2003 Ford Mustang V8-4.6L SOHC VIN X

M/T - TR36550 5SPD JUMPS OUT OF GEAR/ GEAR CLASH

TSB 04-15-6

TR3650 MANUAL TRANSMISSION - JUMPS OUT OF
GEAR 2ND AND/OR 3RD - CLASH NOISE AND/OR
RASPY FEEL ON GEAR ENGAGEMENT

Figure 1

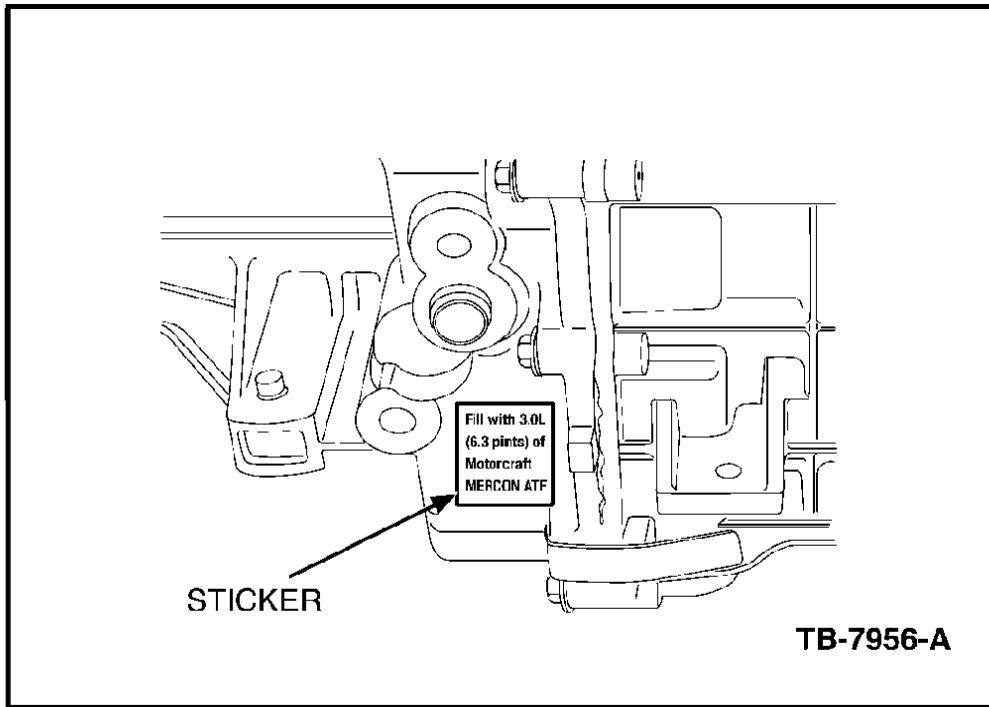
4. Clean oil from area 26 mm (1") below the transmission fill plug (Figure 1) and install the oil fill sticker included in the kit.

6. Fill the transmission with 3.0 liters (6.3 pints) of Motorcraft Mercon ATF (XT-2-QDX). The full fill level is approximately 19 mm (0.75") below the fill hole.
